SUBJECT: CALVERT CLIFFS NUCLEAR POWER PLANT, UNITS 1 AND 2 - STAFF ASSESSMENT OF INFORMATION PROVIDED PURSUANT TO TITLE 10 OF THE *CODE OF FEDERAL REGULATIONS* PART 50, SECTION 50.54(f), SEISMIC HAZARD REEVALUATIONS FOR RECOMMENDATION 2.1 OF THE NEAR-TERM TASK FORCE REVIEW OF INSIGHTS FROM THE FUKUSHIMA DAI-ICHI ACCIDENT (TAC NOS. MF3970 AND MF3971)

STAFF ASSESSMENT BY THE OFFICE OF NUCLEAR REACTOR REGULATION

RELATED TO SEISMIC HAZARD AND SCREENING REPORT

CALVERT CLIFFS NUCLEAR POWER PLANT, UNITS 1 AND 2

Figure 3.3-1 Plot of NRC Staff and Licensee's Base Case Shear-Wave Velocity Profiles for the Calvert Cliffs site

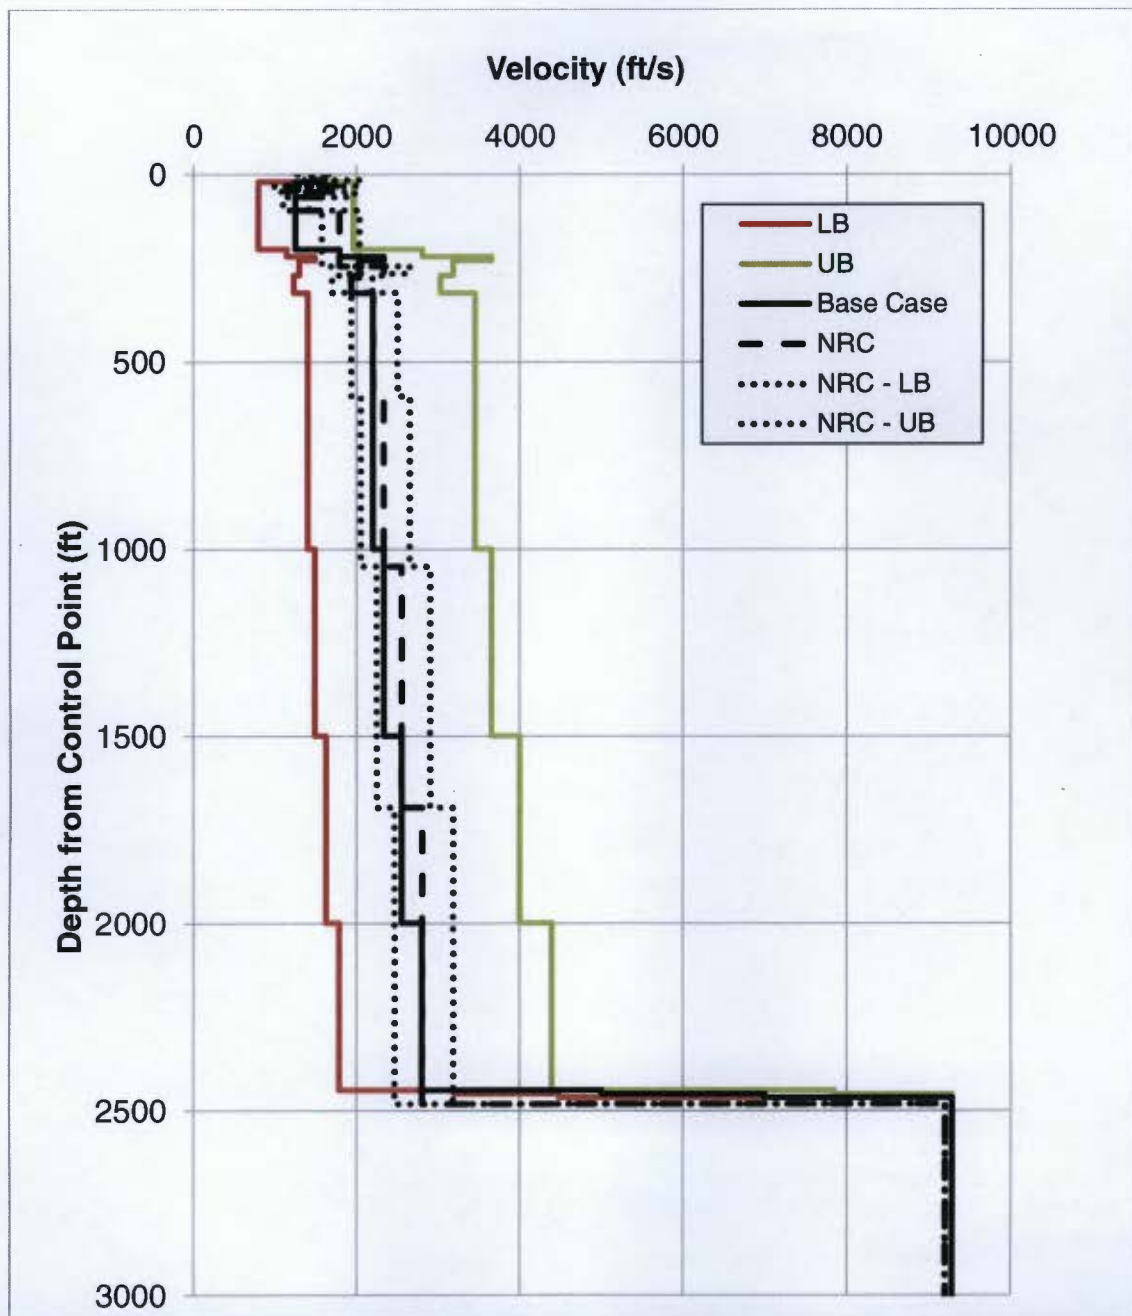
Overall, the staff's velocity profiles are similar to those developed by the licensee. Similar to the licensee, the staff also used the SPID guidance in developing the appropriate dynamic properties by using the appropriate EPRI soil and Peninsular curves. The staff's model, however, assumed a linear response below a depth of 360 ft [110 meters] whereas the licensee assume a linear response below a depth of 500 ft [152 meters]. For the site kappa values, the staff also estimated a value above 0.04 s and therefore, used a kappa value 0.04 s to be consistent with the SPID guidance.

Figure 3.3-2 Plot Comparison of the NRC Staff and the Licensee's Median Amplification Functions and Uncertainties for the Calvert Cliffs site

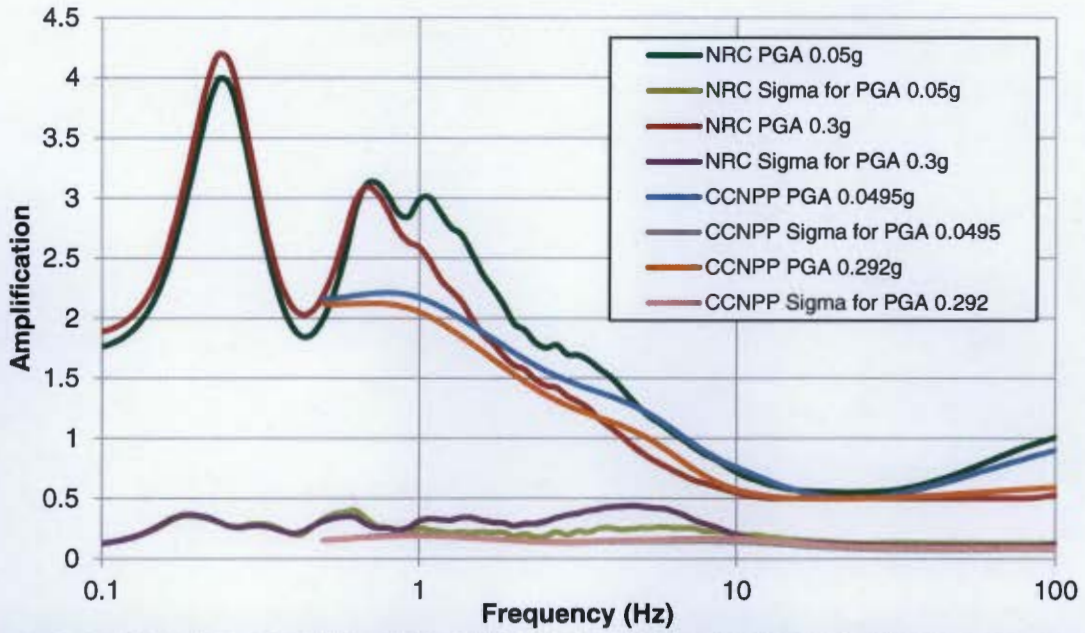
Figure 3.3-2 of this assessment shows a comparison of the staff's and licensee's median site amplification functions and uncertainties (± 1 standard deviation) for two of the eleven input loading levels. Even though there are some variations in site amplifications due to differing input model parameters, as shown in Figure 3.3-3 of this assessment, these differences do not impact the final control point hazard curves. Appendix B of the SPID provides guidance for performing site response analyses, including capturing the uncertainty for sites with less subsurface data; however, the guidance is neither entirely prescriptive nor comprehensive. As such, various approaches in performing site response analyses, including the modeling of uncertainty, are acceptable for this application.

Figure 3.4-1 Comparison of the NRC staff GMRS with Licensee's GMRS and the Unit Nos. 1 and 2 SSE for the Calvert Cliffs site

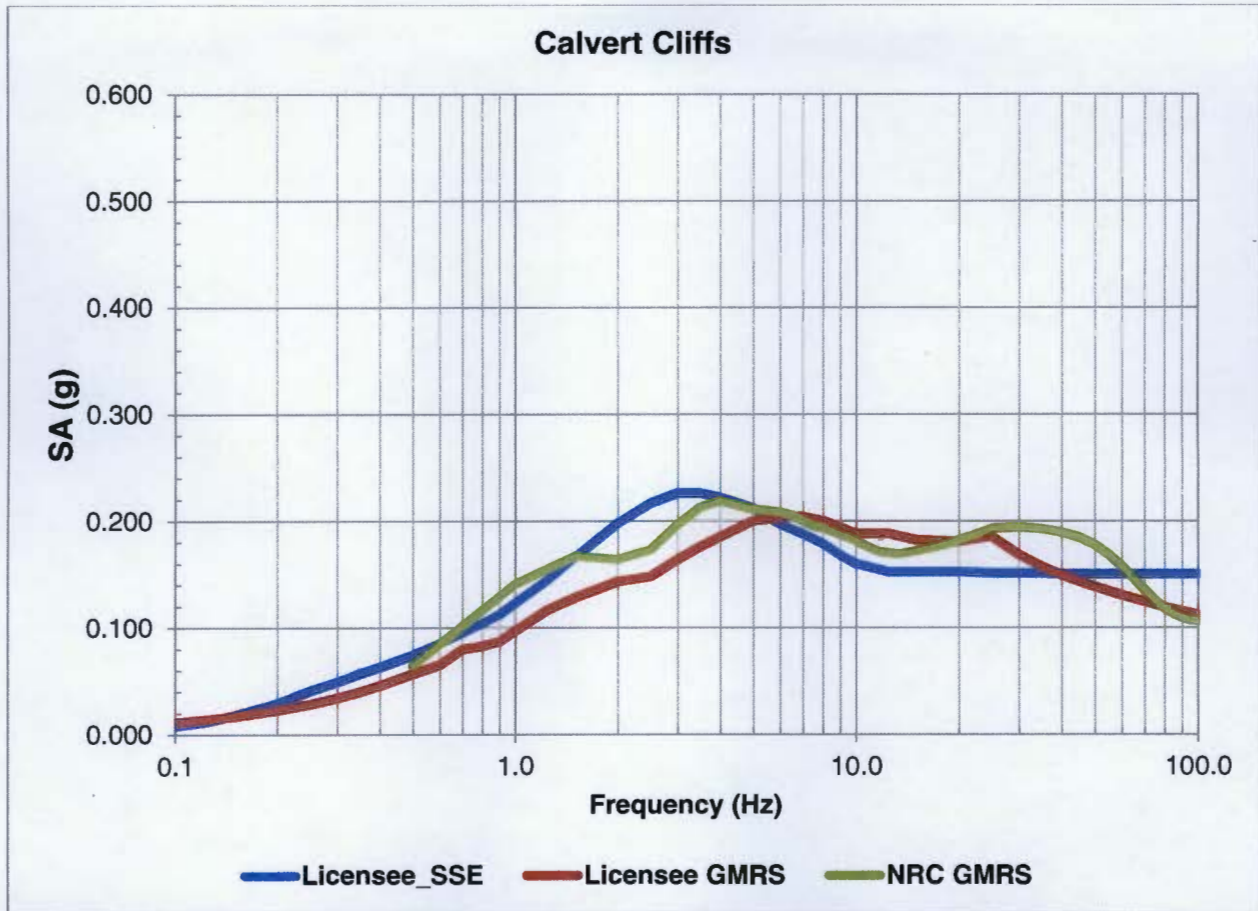
The staff independently calculated the 10^{-4} and 10^{-5} UHRS using the results of its confirmatory PSHA and site response analyses, as described in Sections 3.2 and 3.3 of this staff assessment, respectively. Figure 3.4-1 of this assessment shows a comparison of the GMRS determined by the licensee to that determined by the staff. As shown in Figure 3.4-1, the NRC's GMRS shape is generally similar to the licensee's GMRS across the entire frequency range.

The staff confirms that the licensee used the present-day guidance and methodology outlined in RG 1.208 and the SPID to calculate the horizontal GMRS, as requested in the 50.54(f) letter. The staff performed both a PSHA and site response confirmatory analysis and achieved results consistent with the licensee's horizontal GMRS. As such, the staff concludes that the GMRS determined by the licensee adequately characterizes the reevaluated hazard for the CCNPP site. Therefore, this GMRS is suitable for use in subsequent evaluations and confirmations, as needed, for the response to the 50.54(f) letter.
